# HURRICANE CITY UTAH

### Hurricane Planning Commission Meeting Agenda

March 10, 2022

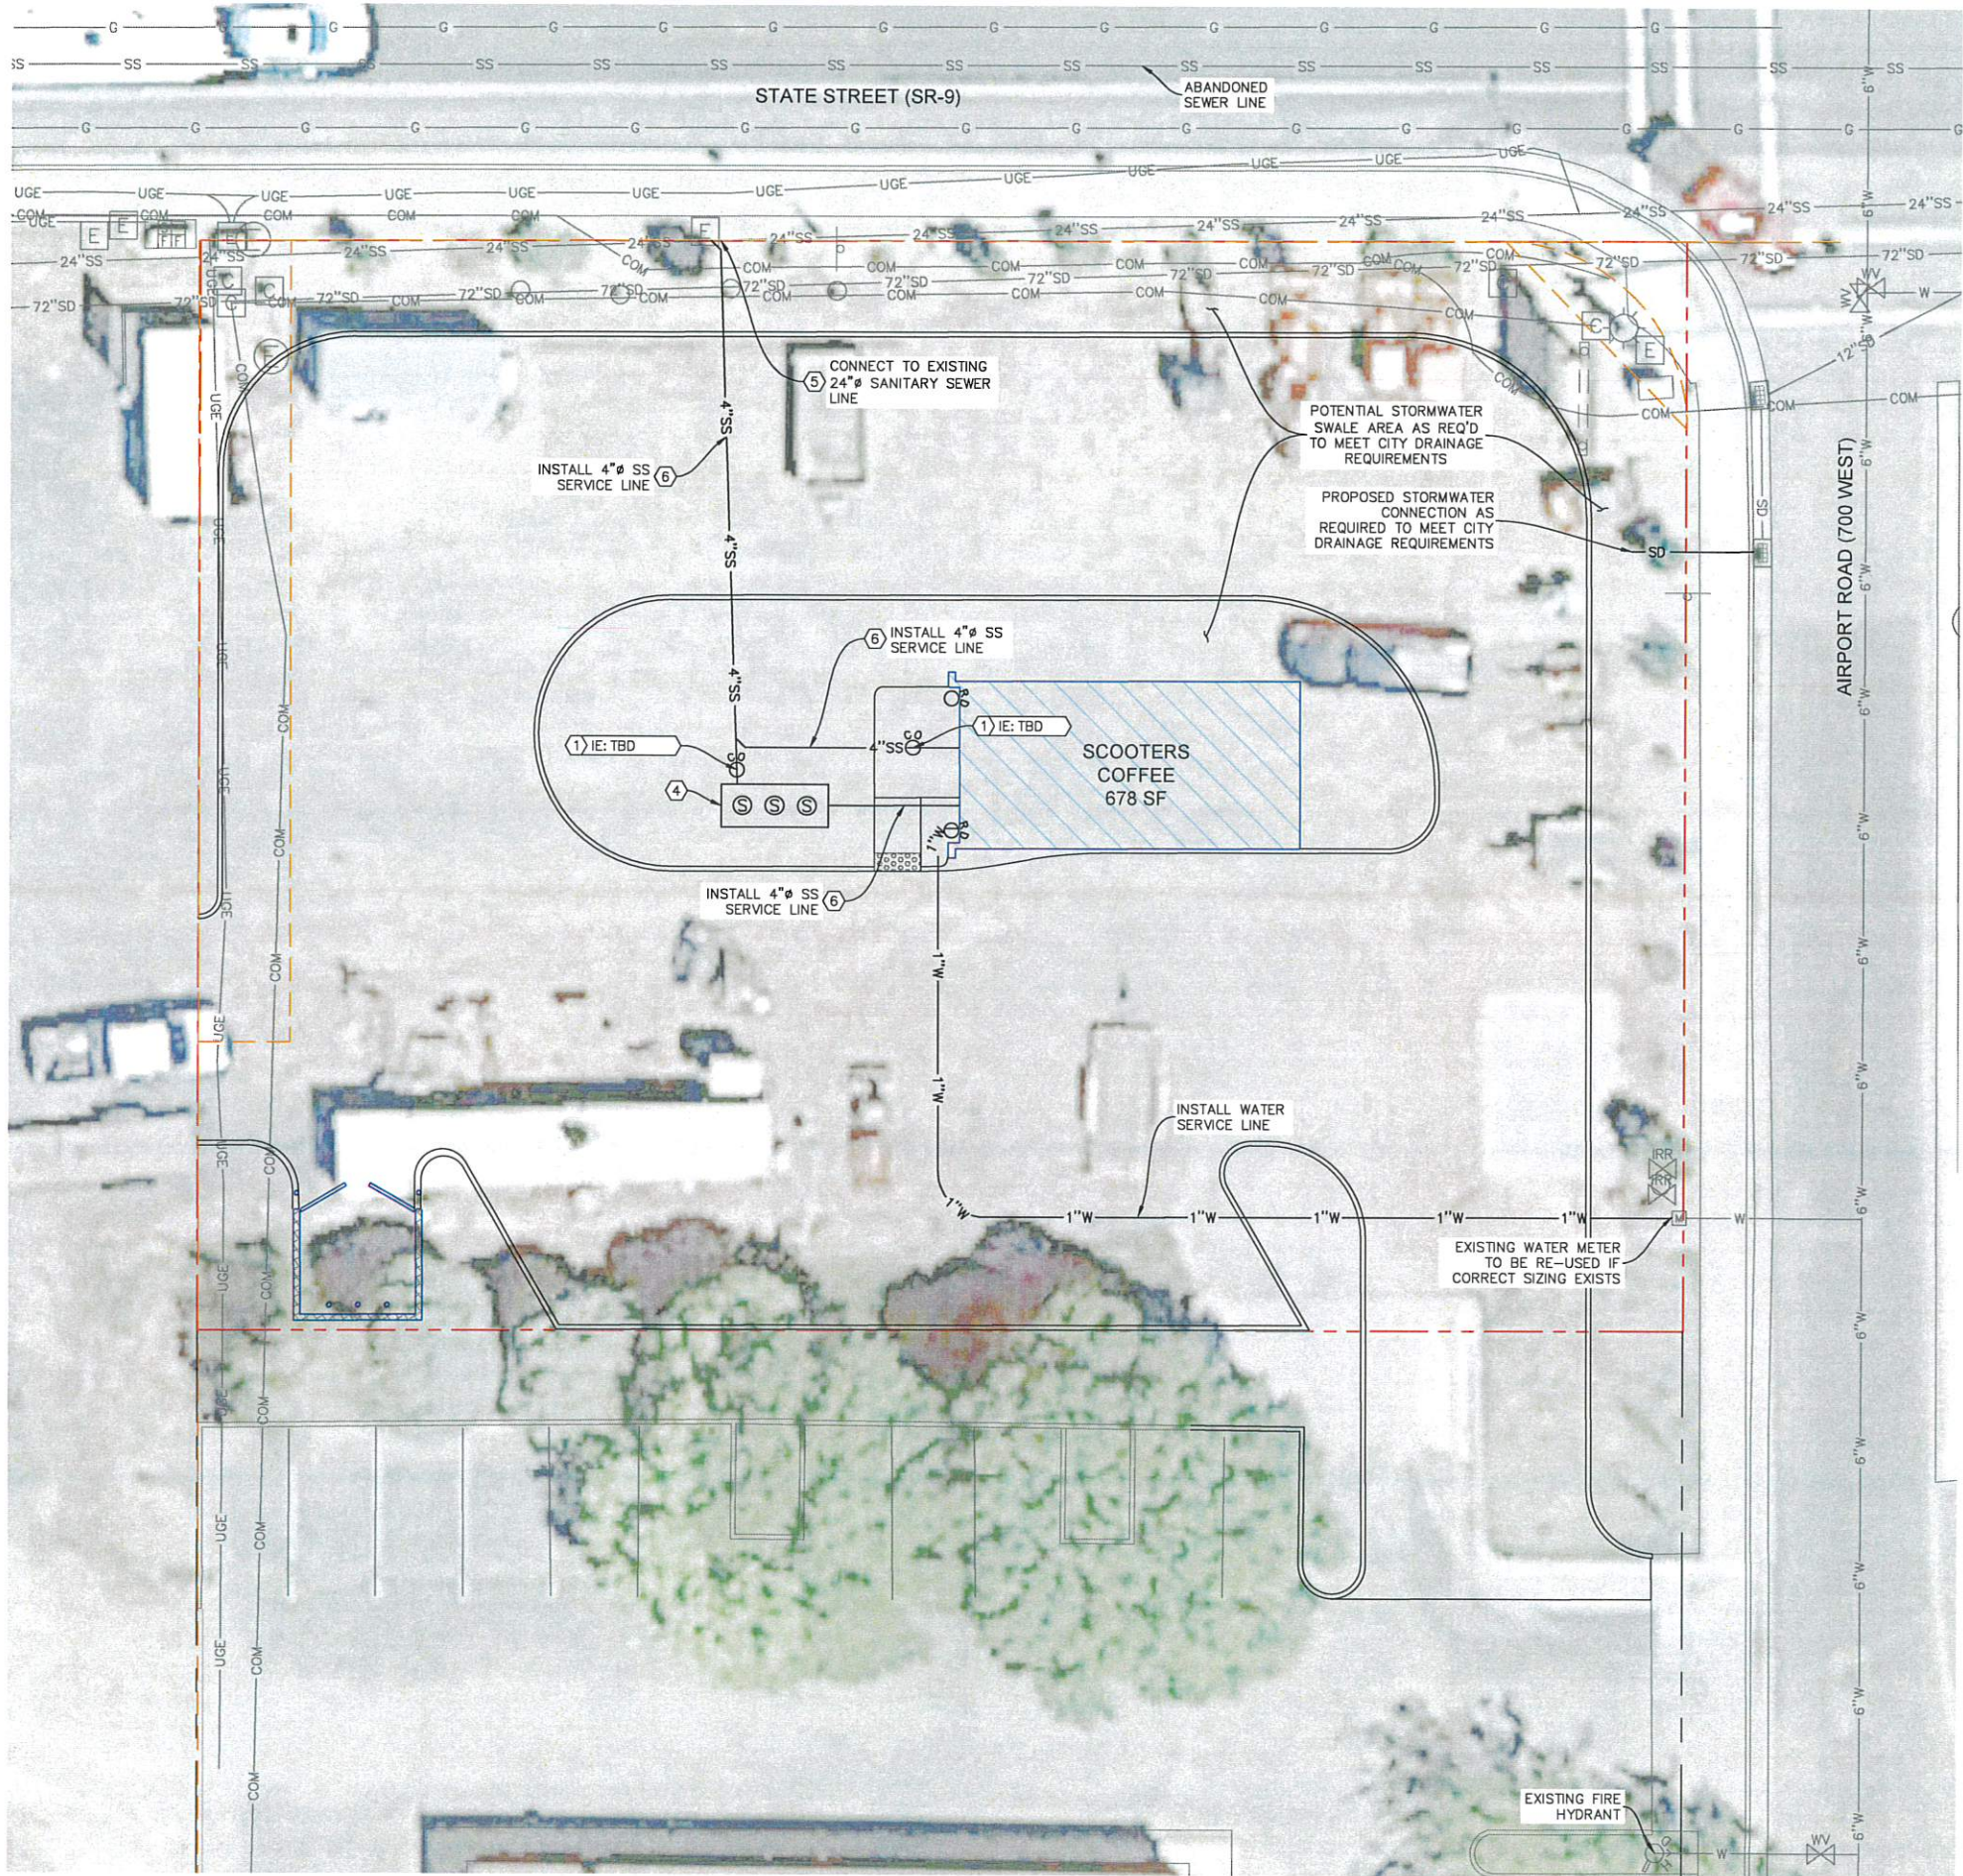
3. Landscape: Hurricane City code requires that a landscape buffer of 10' wide shall front each right-of-way. The site plan does show this area.

5. Access: The City is the property owner to the south, where the main access will be located. The City has just granted an easement to this property for access. The plan appears that they are wanting to make some changes to the southern access point by widening the asphalt width. Any changes of the drive and access point through the City's property will need additional review, but generally, staff does not recommend any changes without additional information. Staff would

recommend that the applicant reach out to Interstate Rock (the property owner to the west) to coordinate shared access points between the two of them.

**Recommendation:** Staff recommends the Planning Commission review this application based on standards with Hurricane City Code. Staff would recommend approval of this preliminary site plan subject to JUC and staff comments.

*Approved site plan*

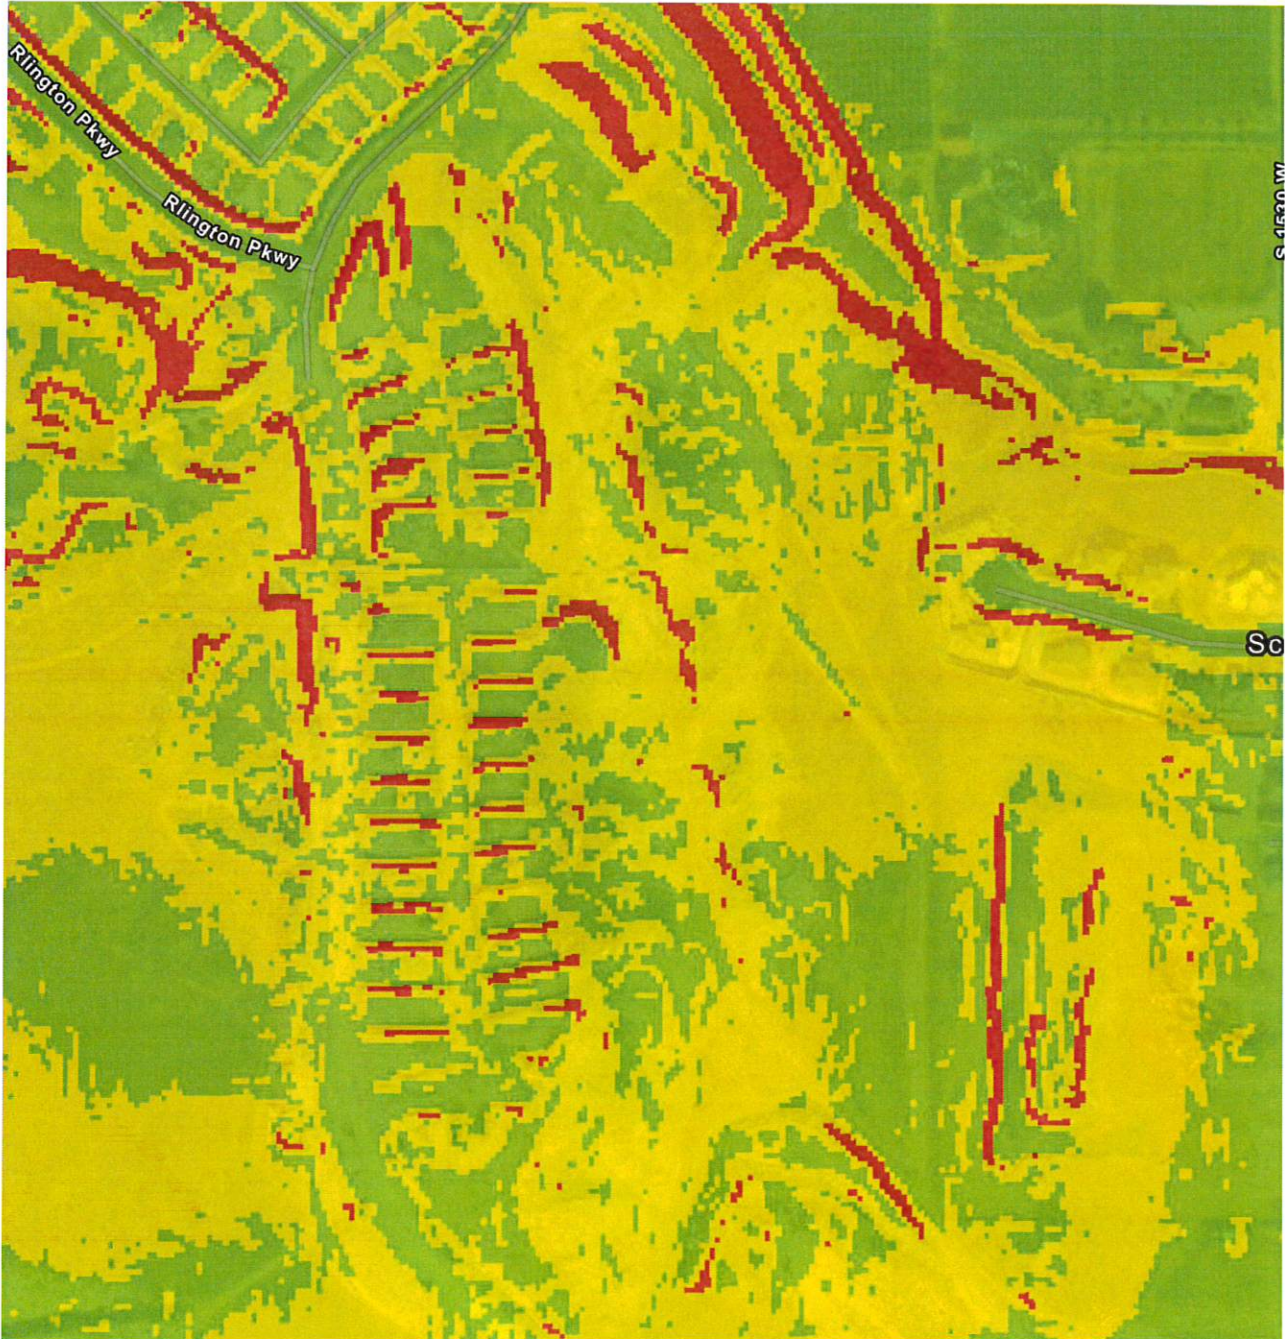
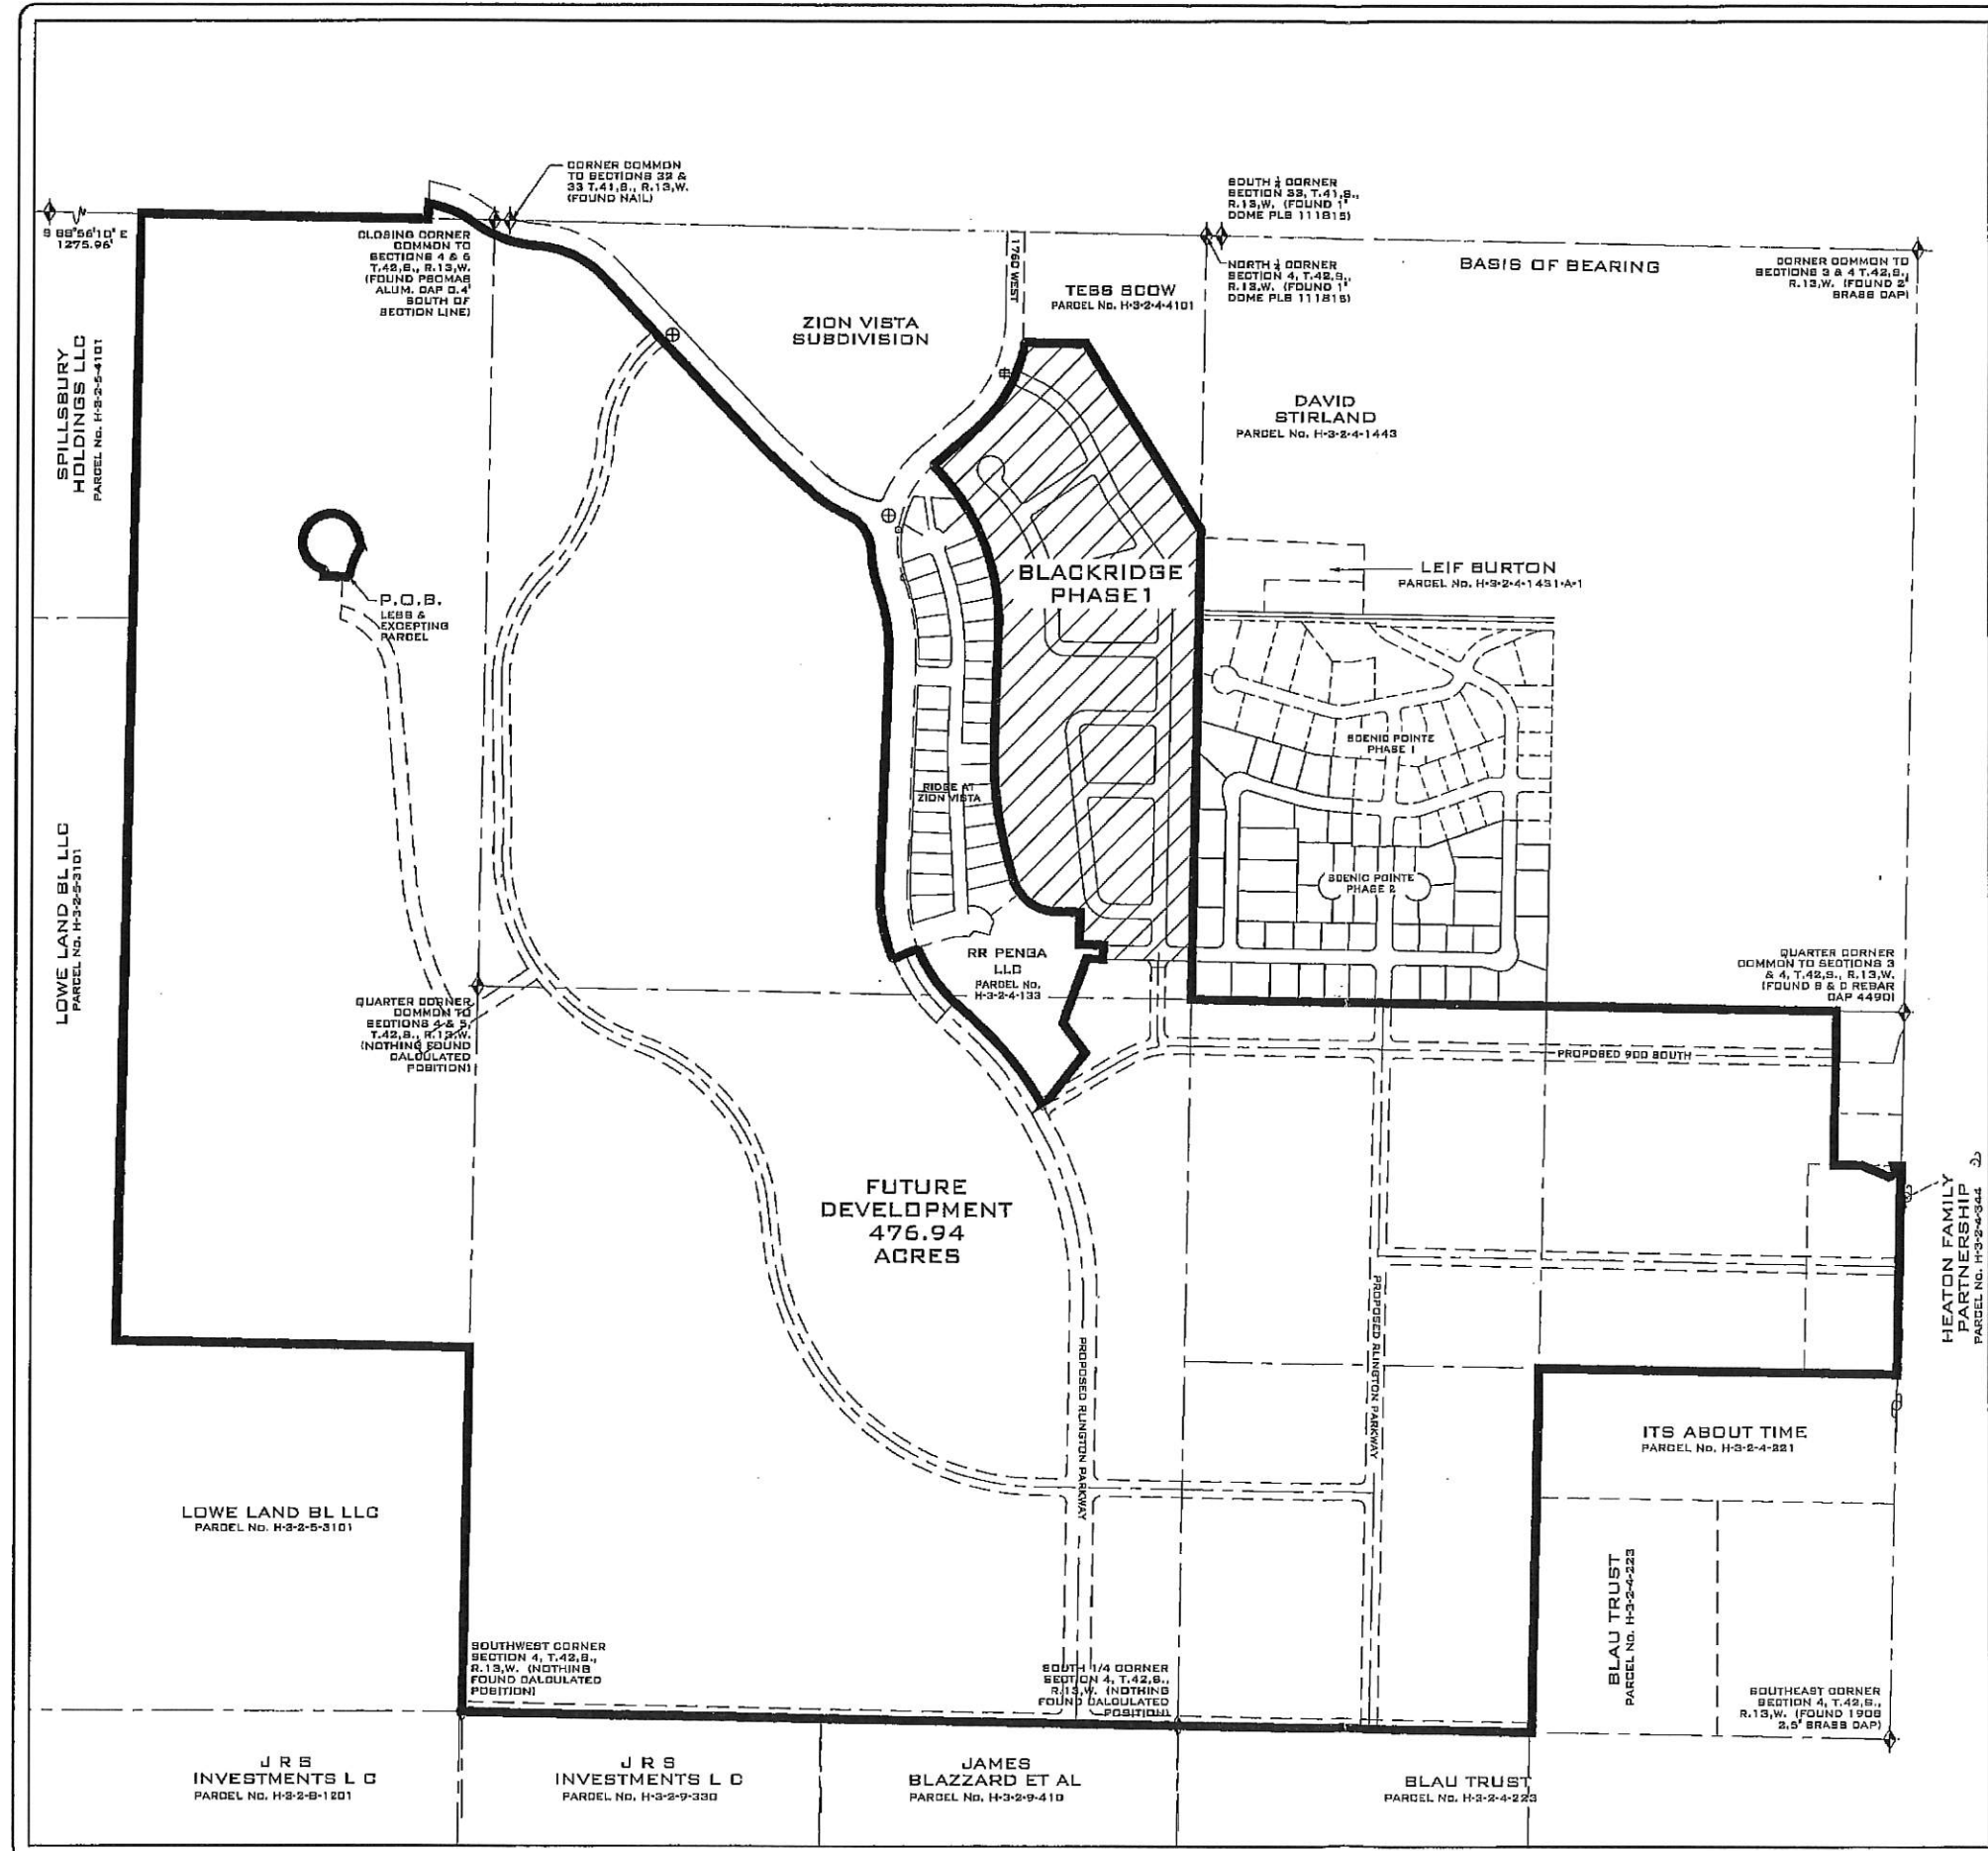
Because of the difference in the site plan and preliminary plat, staff is unable to do a complete review. Staff has decided to do a review of this plat and area under the assumption that the development agreement will likely be amended but will not recommend approval at this time.

2. They are proposing some open space between this phase and the Ridge at Zion Vista but most of that is hillside and is not proposing any access to that open space. If the plan is updated they will need to connect to the trail in The Ridge at Zion Vista to continue the trail.

**Recommendation:** Staff recommends the Planning Commission review this application based on standards with Hurricane City Code. Staff would recommend tabling this application until the Collina Tinta development agreement is amended and until the sensitive lands issues are resolved.
